REMARKS

Claims 1-33 were presented for examination and were pending in this application. In an Office Action dated December 21, 2004, Claim 12 was objected to as allowable if rewritten in independent form, and Claims 1-11 and 13-33 were rejected. Applicant thanks Examiner for Allowance of Claim 12. Applicant also thanks Examiner for examination of the claims pending in this application and addresses Examiner's comments below.

IN THE DRAWINGS:

FIG. 2

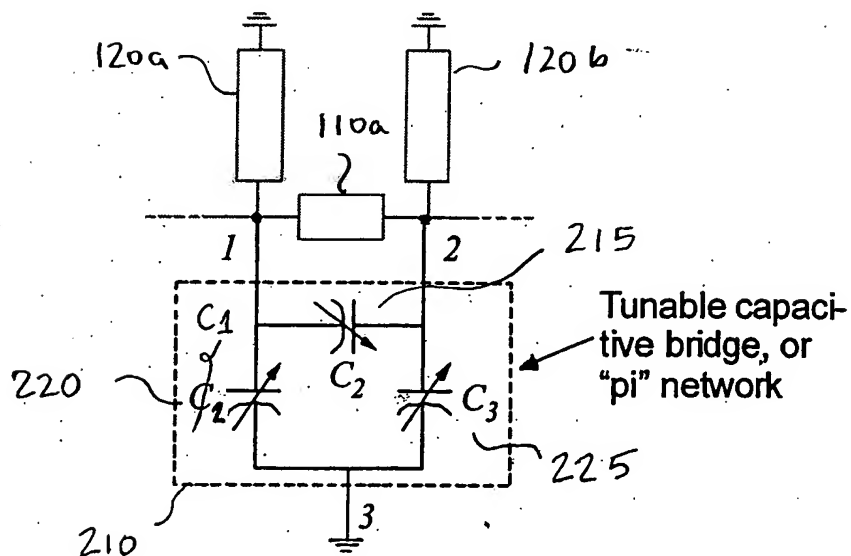
The Examiner objected to FIG. 2, stating, “[t]he drawings are objected to because first tunable variable capacitor ‘C₁’ (page 8, paragraph [0028]) is not shown on the drawing.”

Applicant has amended FIG. 2 to properly identify first tunable variable capacitor C₁. Applicant has also amended paragraphs [0028] and [0029] to properly reference capacitors C₁ and C₂ in FIG. 2. No new matter is introduced as a result of the amendments.
